Access Compliance Report

Public Rights-of-Way

Intersection ID: 5224	Main Street: FROSTMOOR_PL	Cross Street: GROVETON_CT	Location: SE
ADA ID: 484E52ECA417	Ramp Type: Perp	Initial Pass/Fail: Fail	Overall Compliance: No
		Severity Score: 50

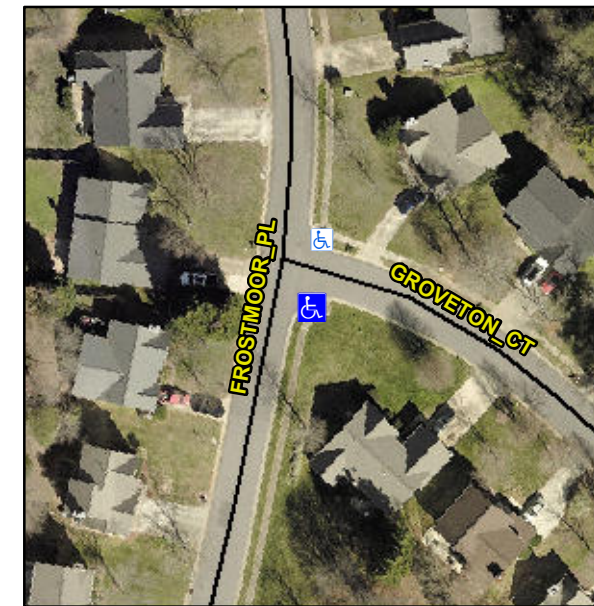
Not Found, R304.2.2, R304.5.3

Compliance	Description	Data	Compliance	Description	Data
N/A	Ramp Length (in)	48.0	No	Ramp Slope (%)	20.0
Yes	Ramp Width (in)	48.0	No	Ramp XSlope (%)	9.9
N/A	Flare Type LT	N/A	N/A	Flare Type RT	N/A
N/A	Flare Slope LT (%)	N/A	N/A	Flare Slope RT (%)	N/A
N/A	Flare Traversable LT?	N/A	N/A	Flare Traversable RT?	N/A
N/A	Landing Length (in)	N/A	N/A	DWS Provided?	N/A
N/A	Landing Width (in)	N/A	N/A	DWS Contrast?	N/A
N/A	Landing Slope (%)	N/A	N/A	DWS Length (in)	N/A
N/A	Landing X Slope (%)	N/A	N/A	DWS Full Width?	N/A
N/A	Landing Curb? (Y/N)	N/A	N/A	DWS Offset (in)	N/A
N/A	Shared Landing?	N/A			
N/A	Gutter Ponding?	N/A	N/A	Gutter Slope (%)	N/A
N/A	Gutter Lip Ht (in)	N/A	N/A	Gutter X Slope (%)	N/A
N/A	Painted X Walk1?	No	N/A	Painted X Walk2?	N/A
	X Walk 1 Direction	To N		X Walk 2 Direction	N/A
N/A	X Walk 1 Width (in)	N/A	N/A	X Walk 2 Width (in)	N/A
	X Walk 1 Slope (%)	1.6		X Walk 2 Slope (%)	N/A
	X Walk 1 X Slope (%)	7.0		X Walk 2 X Slope (%)	N/A

Remove & Replace Entire Ramp.
